Reigate and Banstead Council

Review of need assessment for a new crematorium at Woodhatch

Peter Linsell (Managing Director)

09/04/2021

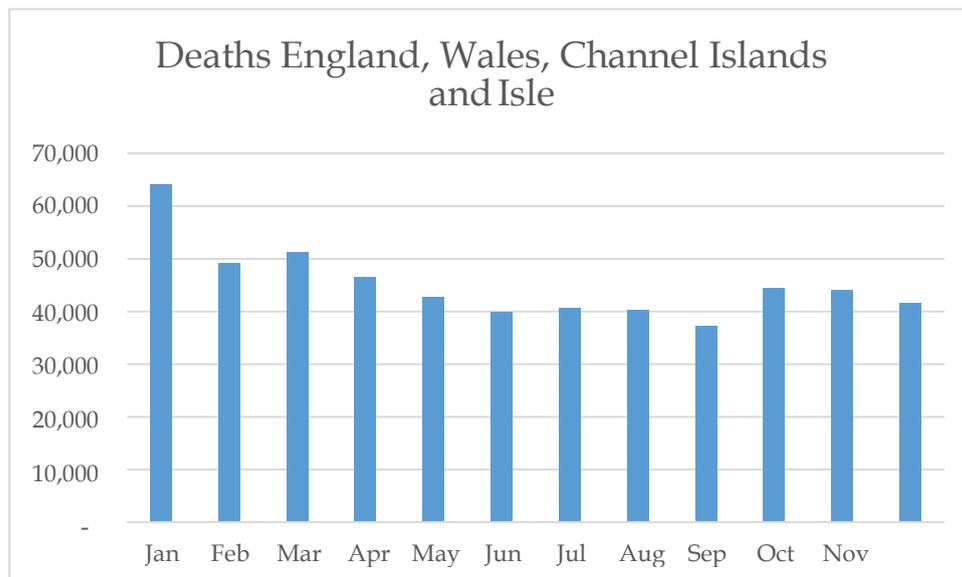
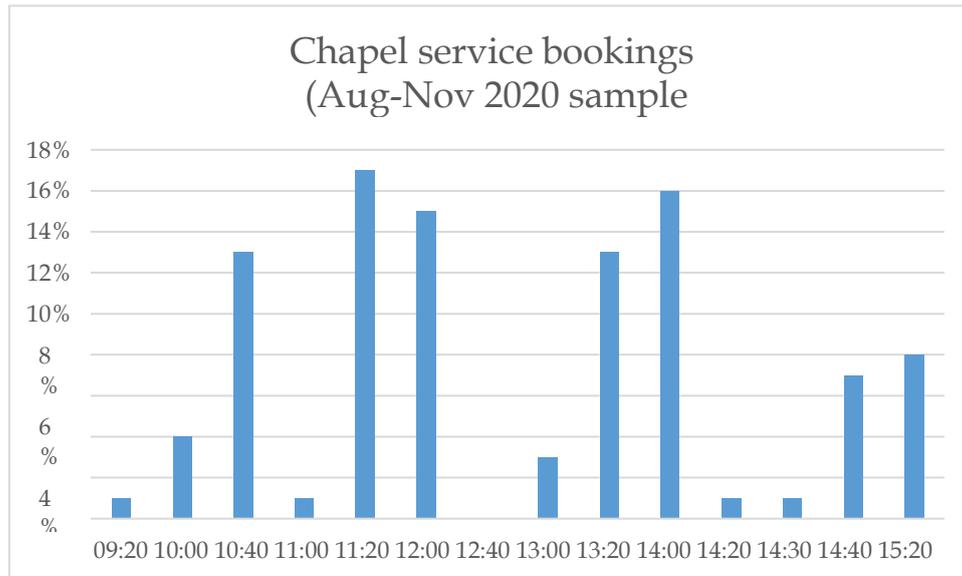
5.4.7	Most funerals take place between 10.30am and 4.00pm	Correct. See chart for a typical crematorium below.
5.4.8	Planning appeals now recognise that each crematorium has 'practical capacity' of 8 service times per day, 2016 service times per year.	Correct. Last service at 3:10, ending at 3:50. We would calculate annual practical capacity as 253 x 8 = 2024 per year.

5.4.9	Death rates throughout the year vary and should be taken account of.	Correct. See chart below.
5.4.9	Operating above 80% of practical capacity places a crematorium under pressure	Correct. Now widely accepted.
